Mosqueda Community Center - Exterior  
4760 East Butler, Fresno

Mosqueda Community Center (MCC)

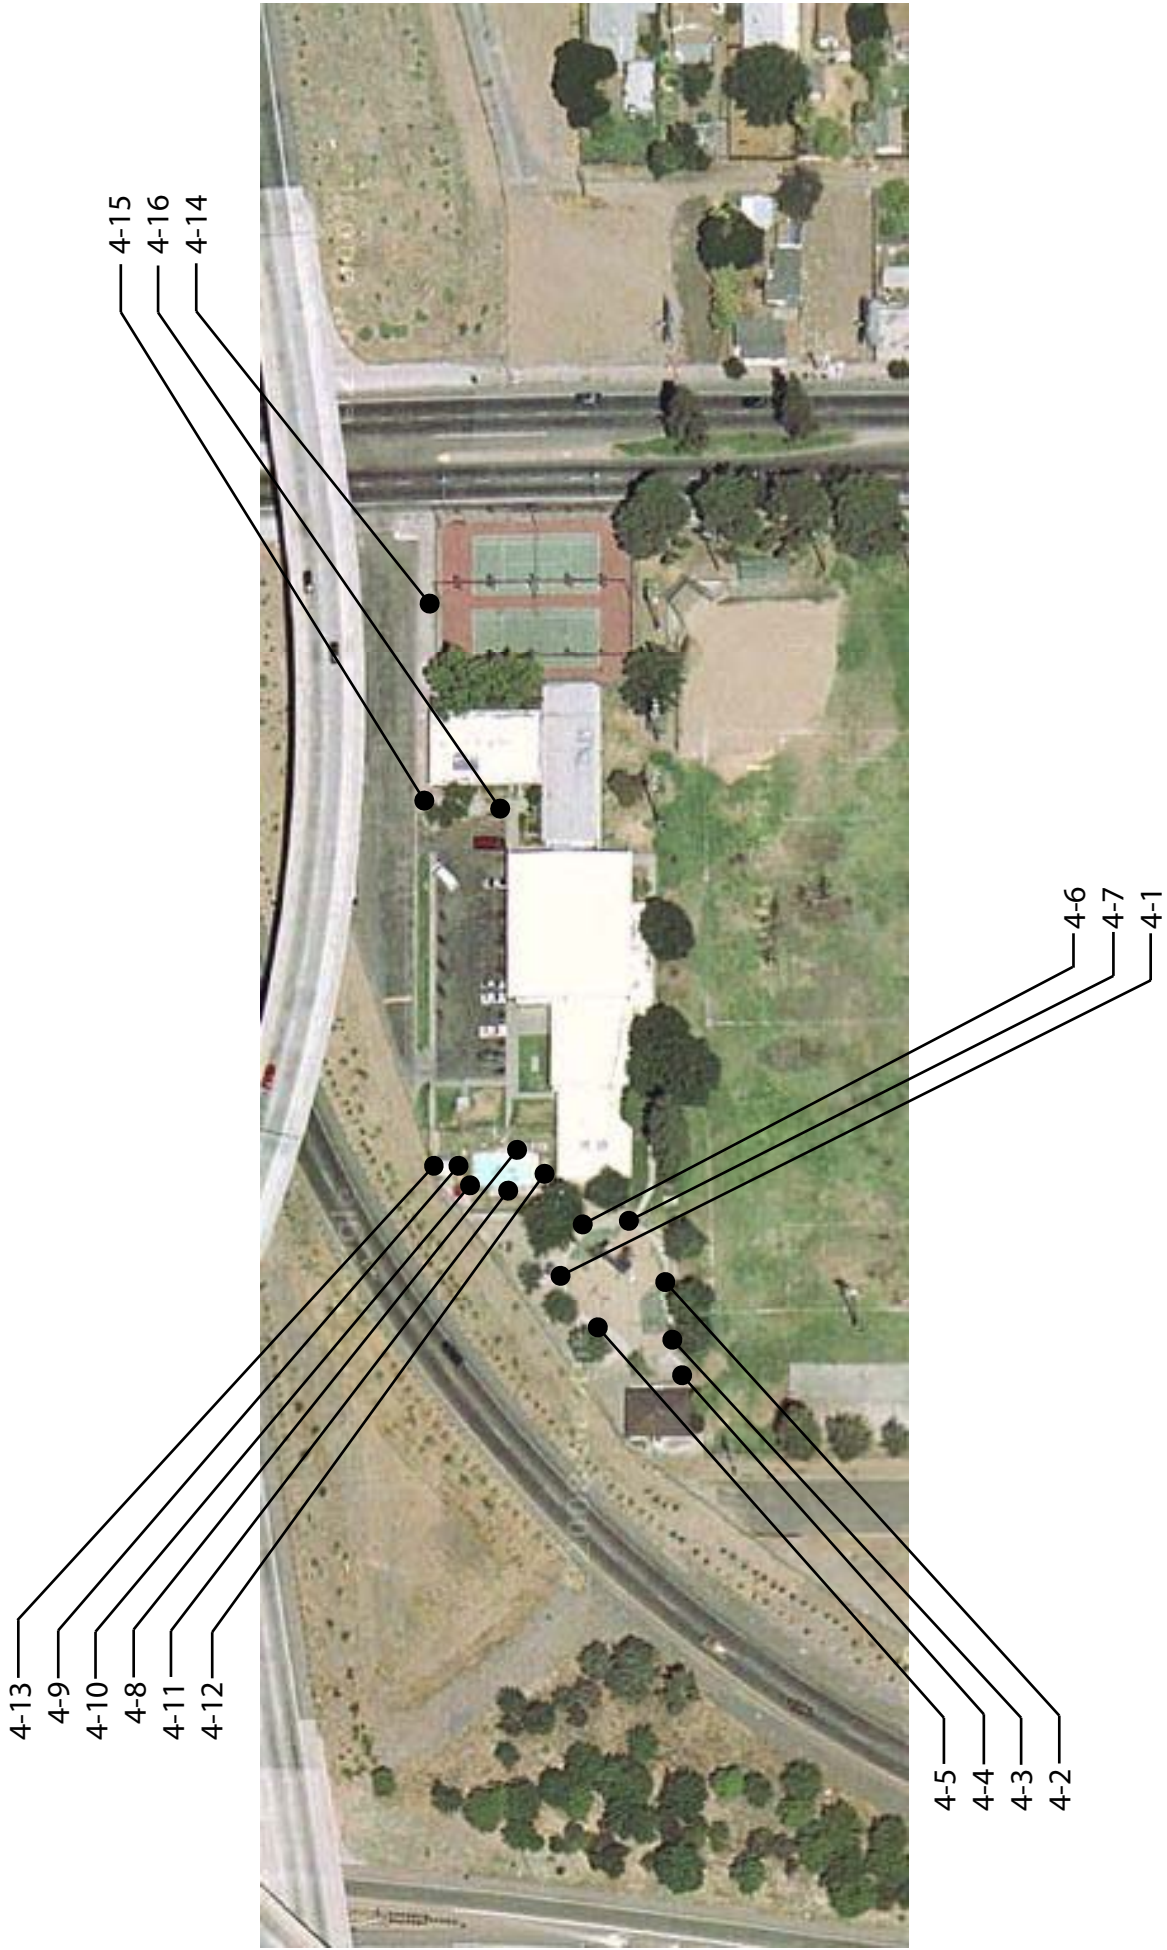
<b>Floor B</b>	
<b>19 - 1 Multiple User Restroom</b>	<b>Priority:2</b>
<b>Replace or reposition dispensers or mirrors</b>	<b>\$0</b>
Notes: Towel dispenser is 57-1/2" (40" max), sanitary napkin dispenser is 48" (40" max), and soap dispenser is 43" (40" max) above the finished floor.	
State: 1115B.8.3	
Federal: 4.23.7	
<b>Insulate water lines</b>	<b>\$0</b>
Notes: Hot water and drain pipes are not insulated.	
State: 1115B.4.3 #4	
Federal: 4.19.4	
<b>Provide or replace stall door hardware</b>	<b>\$0</b>
Notes: Stall door does not have handles on the back. U-shaped handles are not provided. Stall door is not self-closing. Stall door hardware requires grasping and twisting.	
State: 1115B.3.1 #4.5	
Federal: 4.13.9	
<b>Replace or reposition fixtures</b>	<b>\$0</b>
Notes: Space from the wall to the centerline of the toilet is 19" (18" req).	
State: 1115B.7.1.3	
Federal: 4.17.3	
<b>Replace toilet or adjust toilet seat height</b>	<b>\$0</b>

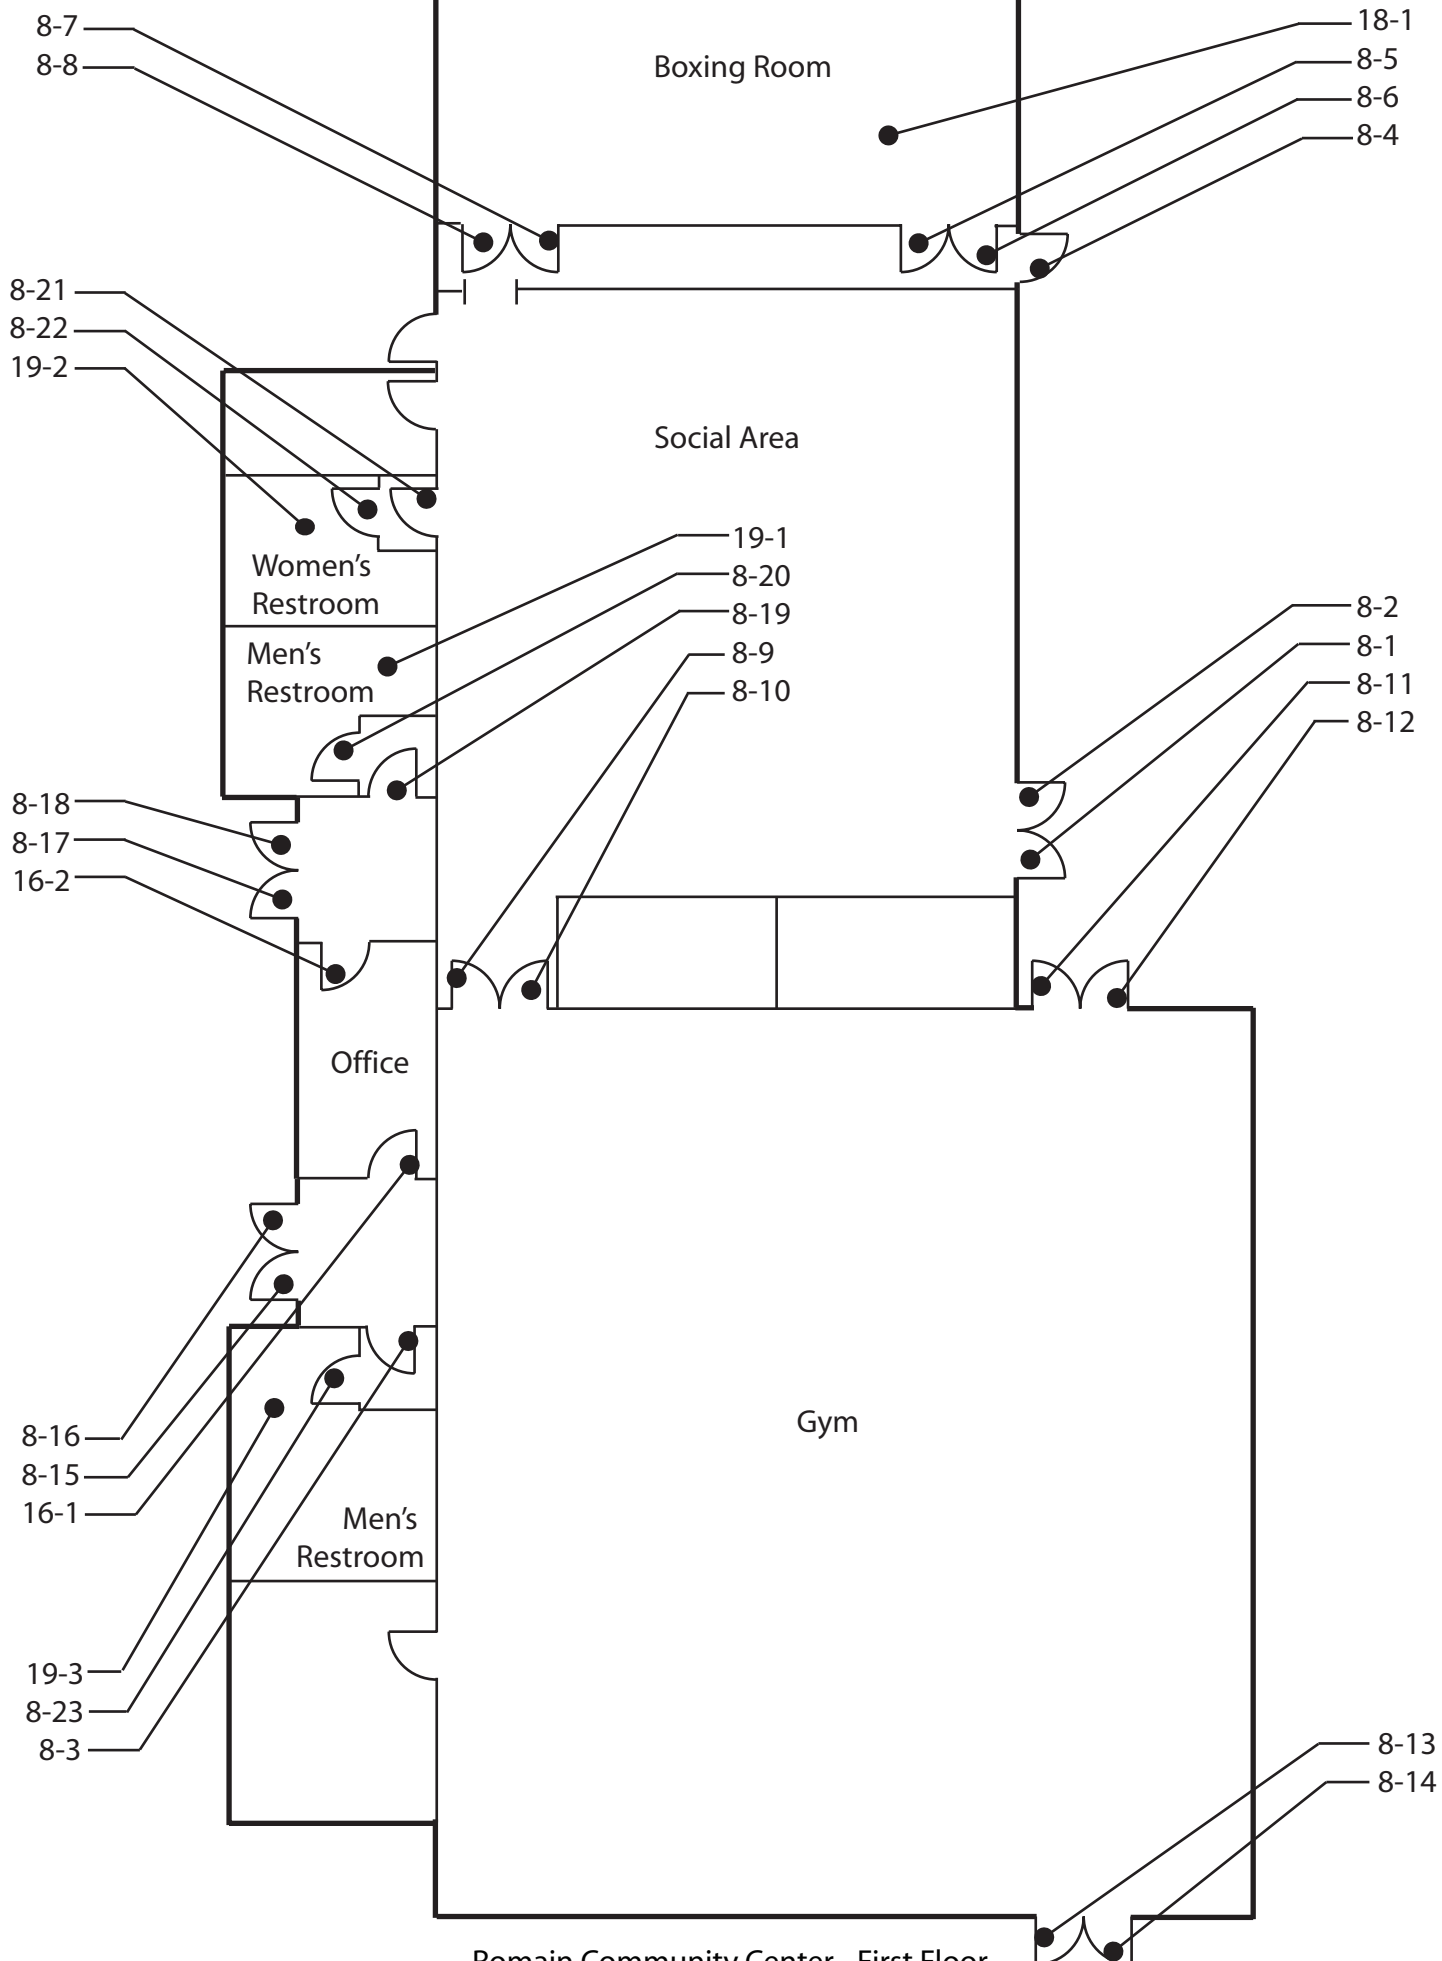
<b>Exterior</b>	
<b>29 - 3</b>	<b>Game and Sports Area</b> <span style="float: right;">Priority:2</span>
<b>Provide an accessible path of travel</b>	<b>\$2,000</b>
Notes: Accessible route to the 2 baseball dugouts are not provided.	
State: 1106B.1	
Federal: -	
<b>Enlarge door opening</b>	<b>\$7,000</b>
Notes: Clear width of opening to the 2 dugouts are 30-1/2" (32" min).	
State: -	
Federal: 4.2.1	
<b>29 - 4</b>	<b>Game and Sports Area</b> <span style="float: right;">Priority:2</span>
<b>Provide an accessible path of travel</b>	<b>\$2,000</b>
Notes: Accessible route to the 2 baseball dugouts are not provided.	
State: 1106B.1	
Federal: -	
<b>Enlarge door opening</b>	<b>\$7,000</b>
Notes: Clear width of opening to the 2 dugouts are 30-1/2" (32" min).	
State: -	
Federal: 4.2.1	
<b>30 - 1</b>	<b>Grandstand/Bleacher (interior or exterior)</b> <span style="float: right;">Priority:2</span>
<b>Provide an accessible path of travel</b>	<b>\$2,000</b>

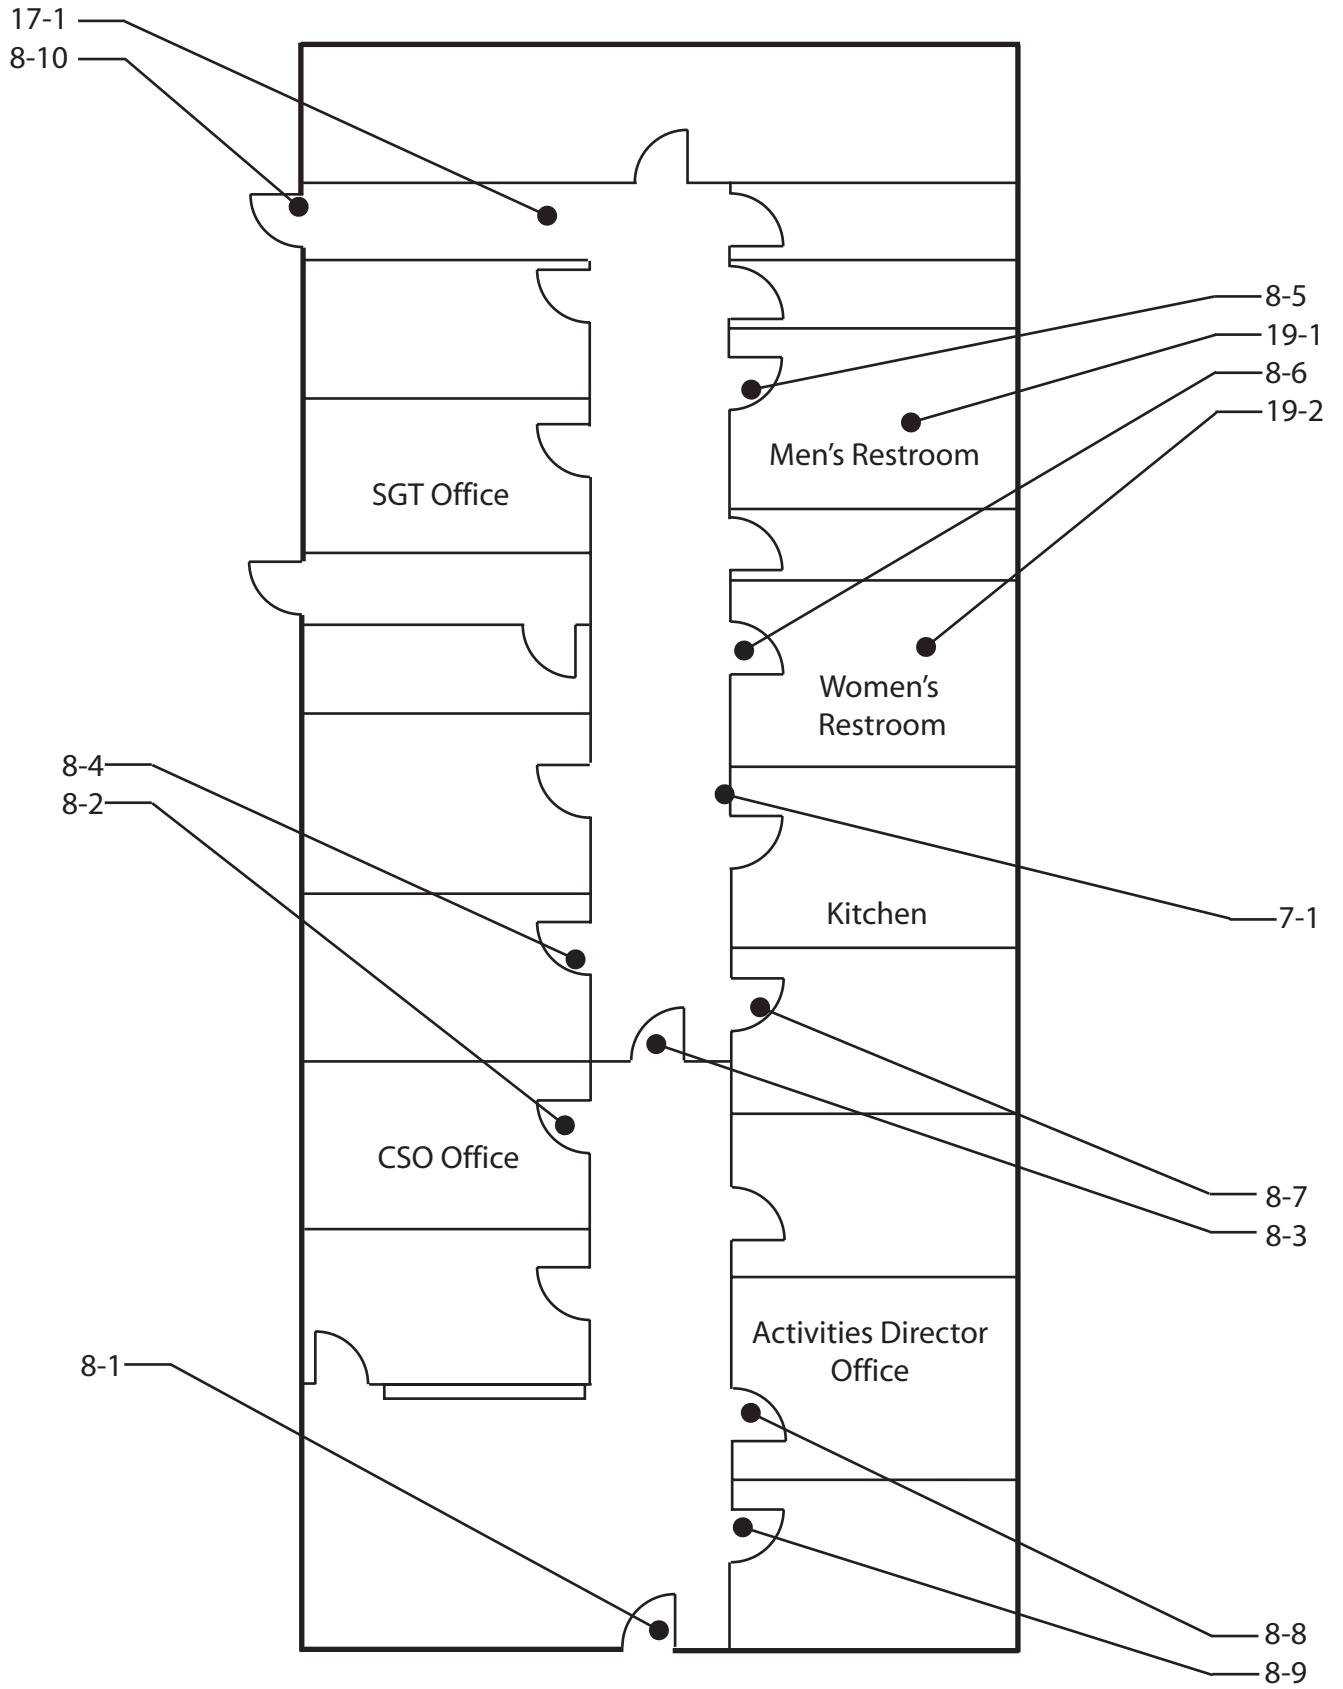
<b>Floor 1</b>	
<b>19 - 3 Multiple User Restroom</b>	<b>Priority: 4</b>
<b>Install sign</b>	<b>\$250</b>
Notes: California required signage is not provided on the door.	
State: 1115B.6	
Federal: 4.30.4	
<b>Install sign</b>	<b>\$250</b>
Notes: Federal required signage is not provided on the door. International Symbol of Accessibility is not provided.	
State: 1115B.6, 1117B.5.1 #1, 1117B.5.5 #3, 1117B.5.8.1.2	
Federal: 4.30.4	
<b>Replace or reposition dispensers or mirrors</b>	<b>\$250</b>
Notes: Mirror is mounted so bottom of reflecting surface is 56" (40" max) above the finished floor.	
State: 1115B.8.1	
Federal: 4.19.6	
<b>Replace or reposition dispensers or mirrors</b>	<b>\$300</b>
Notes: Towel dispenser is 68-1/2" (40" max) and soap dispenser is 42" (40" max) above the finished floor.	
State: 1115B.8.3	
Federal: 4.23.7	
<b>Modify lavatory/counter clearances</b>	<b>\$3,500</b>
Notes: Clear space beneath the lavatory sink is 26-3/4" (29" min) high.

State: 1115B.4.3 #2	
Federal: 4.19.2	
<b>Increase or provide maneuvering or clear floor area</b>	<b>\$2,500</b>
Notes: RESTROOM IS NOT IN USE. IT IS CURRENTLY A STORAGE FACILITY FOR MAINTENANCE. The space under the bowl is 23-1/2" (27" min) when measured 8" from the front edge.	
State: 1115B.4.3 #2	
Federal: 4.19.2	
<b>Insulate water lines</b>	<b>\$100</b>
Notes: Drain pipe is not insulated.	
State: 1115B.4.3 #4	
Federal: 4.19.4	
<b>Replace or reposition urinal</b>	<b>\$3,500</b>
Notes: Flush control is mounted 45" (44" max) above the finished floor.	
State: 1115B.4.2 #2	
Federal: 4.18.2

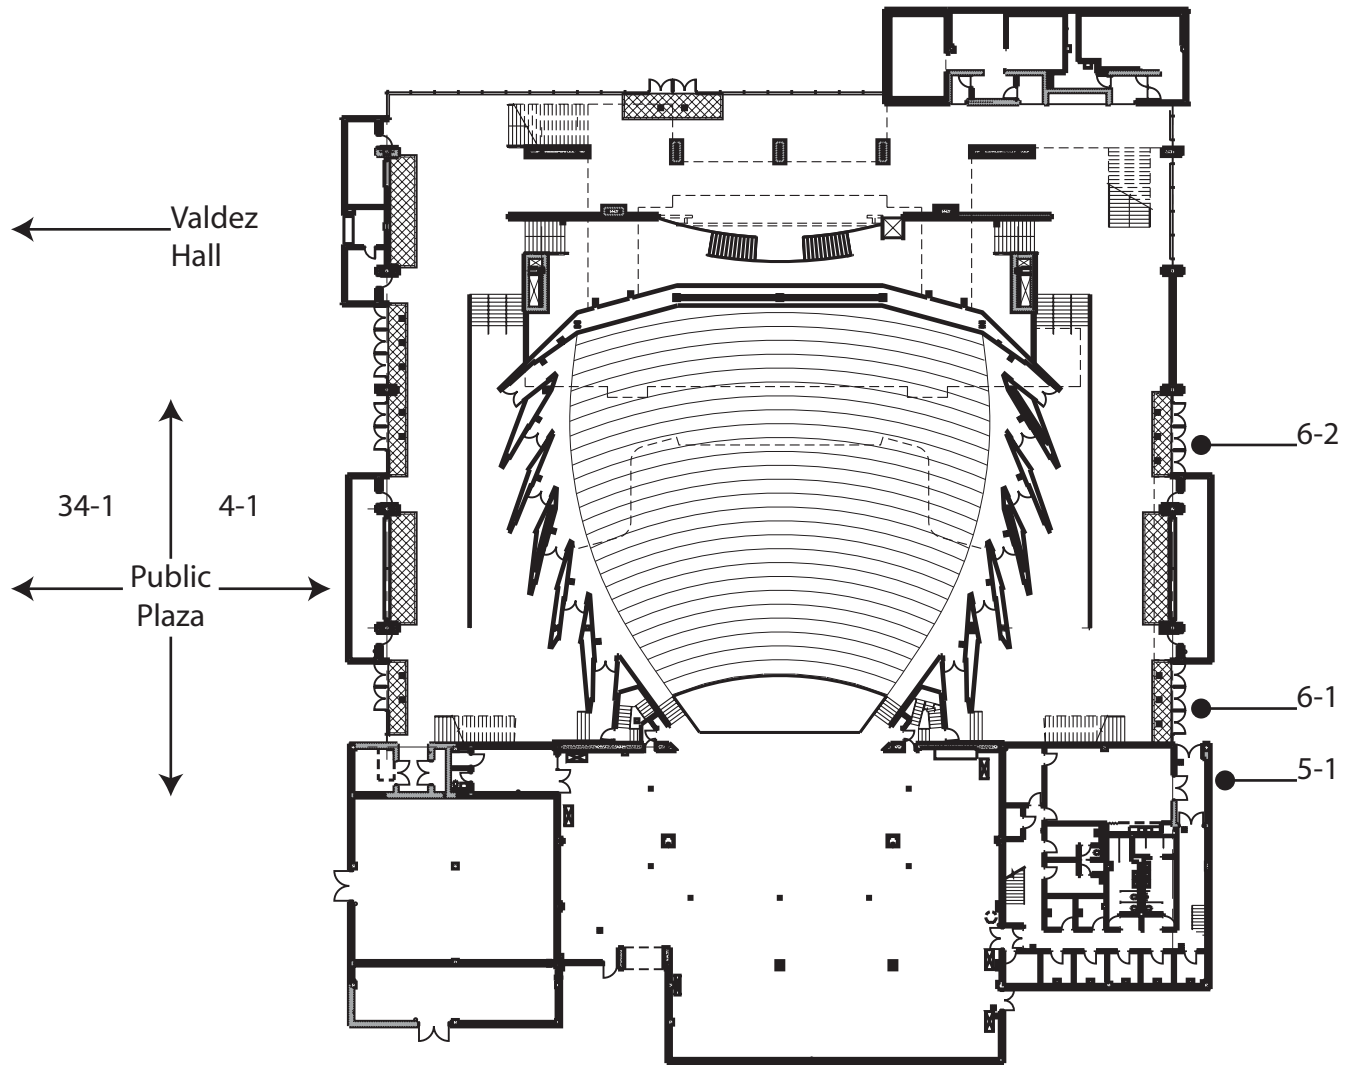
<b>Floor 2</b>	
<b>19 - 2 Multiple User Restroom</b>	<b>Priority:2</b>
<b>Install sign</b>	<b>\$250</b>
Notes: Sign is not appropriate 12" circle. Braille is not provided. Accessible facility is not identified with Int'l Symbol of Accessibility.	
State: 1115B.6, 1117B.5.1 #1, 1117B.5.5 #3, 1117B.5.8.1.2	
Federal: 4.30.4	
<b>Modify lavatory/counter clearances</b>	<b>\$1,500</b>
Notes: Space under bowl is 26" (27" min.).	
State: 1115B.4.3 #2	
Federal: 4.19.2	
<b>Provide or replace stall door hardware</b>	<b>\$200</b>
Notes: Handles not provided on front and back of stall door.	
State: 1115B.3.1 #4.5	
Federal: 4.13.9	
<b>Modify stall partitions and doors</b>	<b>\$2,300</b>
Notes: Door width is 22-1/2" (32" min.). 18" from edge of toilet to partition wall (32" min.). 33" in front of toilet (48" min.). Stall width is 33" (60" min.).	
State: 1115B.3.1 #4.1, 1115B.3.1 #4.4, 1115B.4.1 #1	
Federal: 4.17.3	
<b>Replace toilet or adjust toilet seat height</b>	<b>\$200</b>
